Access Compliance Report

Public Rights-of-Way

Intersection ID: 17739	Main Street: E_WOODLAWN_RD	Cross Street: SOUTH_BV	Location: SW
ADA ID: 2A3F04845F79	Ramp Type: Perp	Initial Pass/Fail: Fail	Overall Compliance: No
		Severity Score: 12.5	
Codes/Mitigation Info/Possible Solution		Field Measurements/Component Compliance

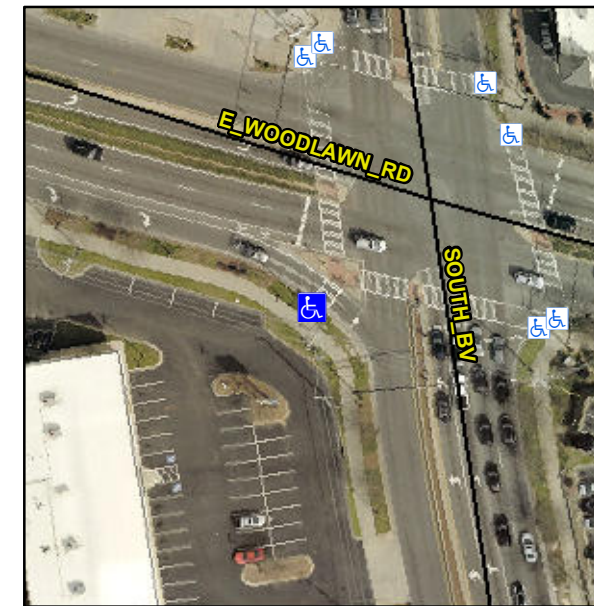
Not Found, R304.2.2

Compliance	Description	Data	Compliance	Description	Data
N/A	Ramp Length (in)	95.0	No	Ramp Slope (%)	10.3
Yes	Ramp Width (in)	48.0	Yes	Ramp XSlope (%)	0.1
N/A	Flare Type LT	N/A	N/A	Flare Type RT	N/A
N/A	Flare Slope LT (%)	N/A	N/A	Flare Slope RT (%)	N/A
N/A	Flare Traversable LT?	N/A	N/A	Flare Traversable RT?	N/A
N/A	Landing Length (in)	N/A	N/A	DWS Provided?	N/A
N/A	Landing Width (in)	N/A	N/A	DWS Contrast?	N/A
N/A	Landing Slope (%)	N/A	N/A	DWS Length (in)	N/A
N/A	Landing X Slope (%)	N/A	N/A	DWS Full Width?	N/A
N/A	Landing Curb? (Y/N)	N/A	N/A	DWS Offset (in)	N/A
N/A	Shared Landing?	N/A			
N/A	Gutter Ponding?	N/A	N/A	Gutter Slope (%)	N/A
N/A	Gutter Lip Ht (in)	N/A	N/A	Gutter X Slope (%)	N/A
N/A	Painted X Walk1?	Yes	N/A	Painted X Walk2?	N/A
	X Walk 1 Direction	To NE		X Walk 2 Direction	N/A
N/A	X Walk 1 Width (in)	96.0	N/A	X Walk 2 Width (in)	N/A
	X Walk 1 Slope (%)	4.0		X Walk 2 Slope (%)	N/A
	X Walk 1 X Slope (%)	0.1		X Walk 2 X Slope (%)	N/A

Remove & Replace Entire Ramp.
